Technical Bulletin		Model 6 Cyl.	Group 3
Subject	Tiptronic Transmission Marking With New Hydraulic Unit	Part Identifier 3730	Number 9601

Models affected: *911 Carrera From Model Year 1995 - on*

NEW TIPTRONIC TRANSMISSION

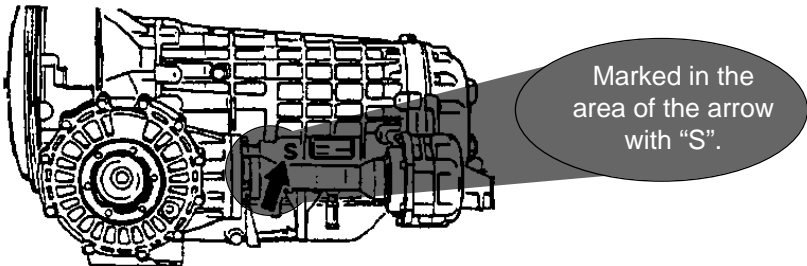
Marked in the area of the arrow with "025" or greater.

Marked in the area of the arrow with "S".

REBUILT TIPTRONIC TRANSMISSION

If a new hydraulic unit, part number 943 325 001 02, is installed in a transmission that previously did not have the new hydraulic unit, the transmission should be marked with a "S" in the area shown on page 1 of this bulletin referring to REBUILT TIPTRONIC TRANSMISSION.
